Full Planning Approval Consultation

Application Number: 252868

Site Address: 54 Denmark Street, Wokingham, RG40 2BB

Proposal: Full application for the proposed change of use of first floor to post-16 SEND hub, including full replacement of external fenestration, installation of a new double-door entrance at first floor level, installation of a new heat pump system, replacement of existing AC units at roof level and installation of additional solar panels.

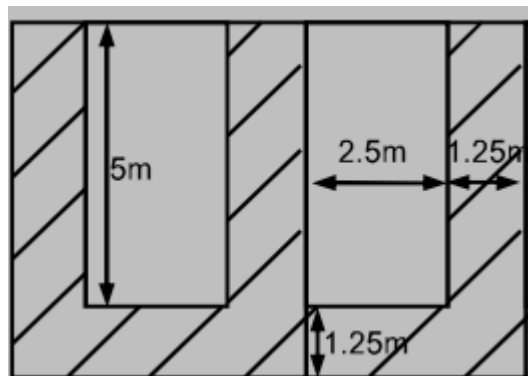
Subject to the nature of the site, provisions of disabled parking space(s) might be required. Extra space is required for disabled parking and recommended dimensions as indicated:
